## **2.4 Hydrologic Engineering**

To ensure that one or more nuclear power plants can be safely operated on the applicant's proposed site and in accordance with the Nuclear Regulatory Commission's (NRC's) regulations, the NRC staff evaluates the hydrologic site characteristics of the proposed site. These site characteristics included the maximum flood elevation of surface water, associated static and dynamic characteristics, and the maximum elevation of groundwater. The characteristic ability of the site to attenuate a postulated accidental release of radiological material into surface water and groundwater before it reaches a receptor is also described.

The staff prepared Sections 2.4.1 through 2.4.14 of this safety evaluation report (SER) in accordance with the review procedures described in NUREG-0800, "Standard Review Plan [SRP] for the Review of Safety Analysis Reports for Nuclear Power Plants: LWR Edition," using information presented in Section 2.4, "Hydrologic Engineering," of the V.C. Summer Nuclear Station (VCSNS) Units 2 and 3 combined license (COL) Final Safety Analysis Report (FSAR) Revision 2; the AP1000 Design Control Document (DCD), Revision 17; responses to staff

**Figure 2.4-3. Plant Site Drainage Basins and Flow Paths (FSAR Figure 2.4.-261)**  
Subbasin 5 was designated by staff for examination of flow effects at the storm water basin in Subbasin 4

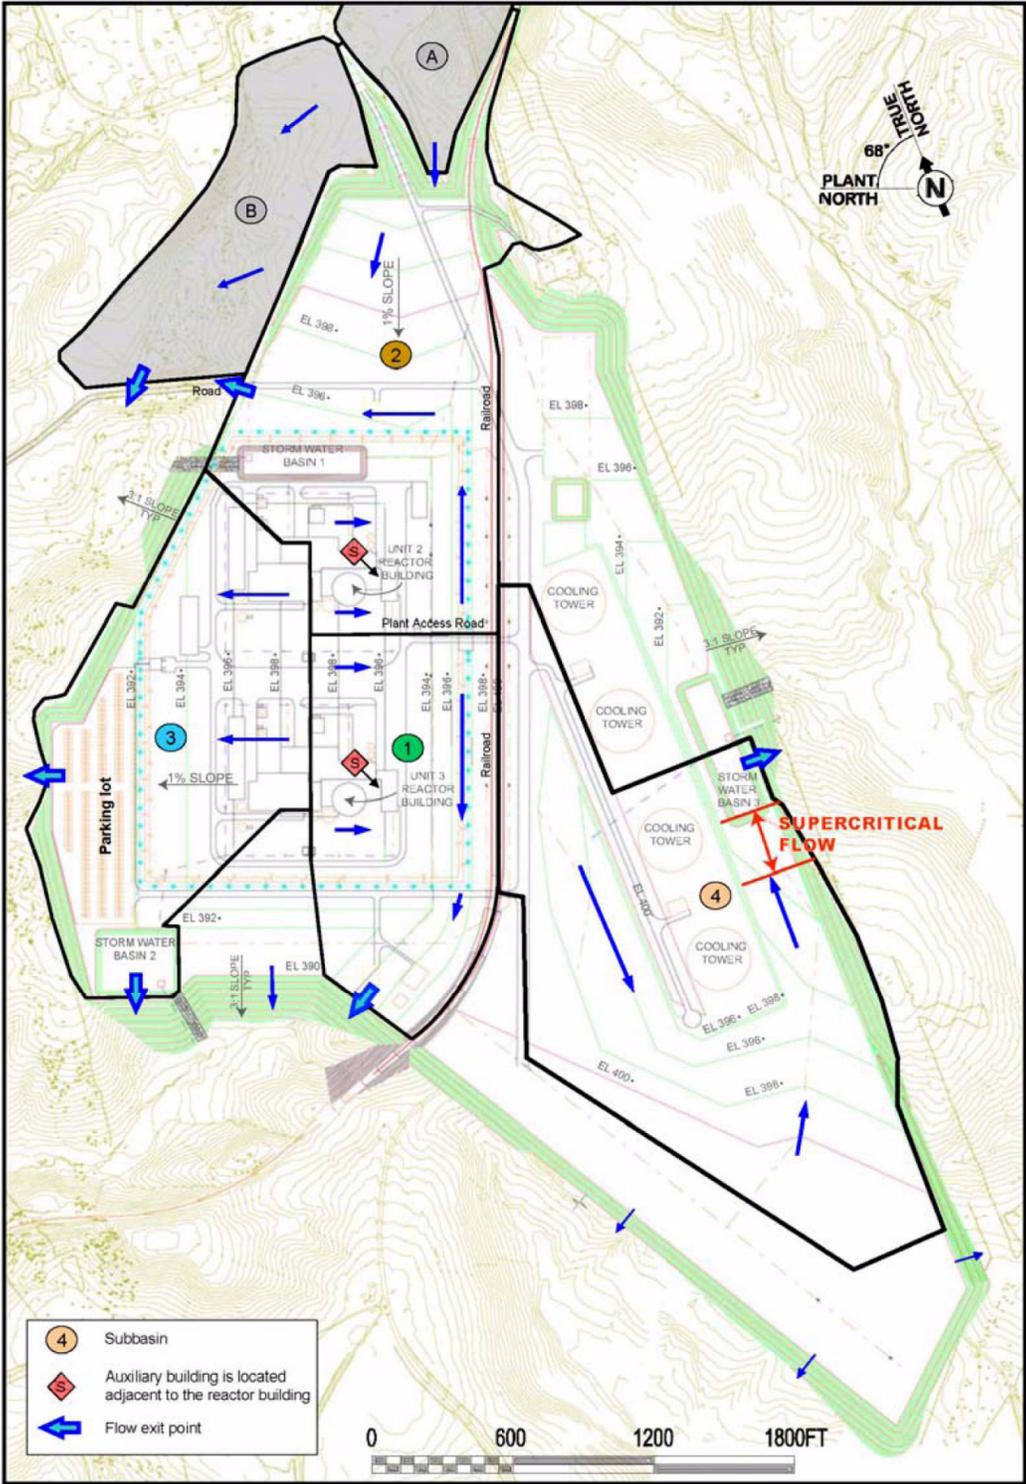
The railroad line coincides with the flow divide for Subbasins 1 and 4. The power block area forms another significant divide for subbasins 1 and 3 as well as Subbasins 2 and 3. An additional drainage area (Subbasin 5) was used by the NRC for the examination of flow effects at Storm Water Basin 3 within Subbasin 4. This additional drainage area is depicted in SER Figure 2.4-3, "Plant Site Drainage Basins and Flow Paths."

The applicant did not consider the runoff from the drainage (northeast portion of plant site) adjoined with Subbasins 2 and 4. The topography map of the drainage area indicates flooding water drains into a storm water basin (SWB 3) that also receives the runoff from Subbasin 4. The staff considered whether the combined runoff might affect the storage and discharge capacity of the storm water basin, by increasing the downstream water surface elevation and potentially affect the upstream water surface elevation. The staff investigated the effect of PMP runoff from the unaccounted drainage area on the flood level in Subbasin 4. Conservatively, the PMP runoff ( $Q = i A = 57.1 \text{ m}^3/\text{s}$  (2015 cfs)) estimated by the staff for the drainage was added to the cumulative inflow (4796 cfs) at the downstream cross-section in the HEC-RAS analysis of Subbasin 4. The result showed the maximum water surface elevation unchanged from the applicant's estimation. Therefore, no risk was associated with the effect of the additional drainage flow on the maximum water surface elevation in Subbasin 4. This is attributed to the supercritical flow occurring at the downstream cross-sections of the model due to the relatively high bed slope.
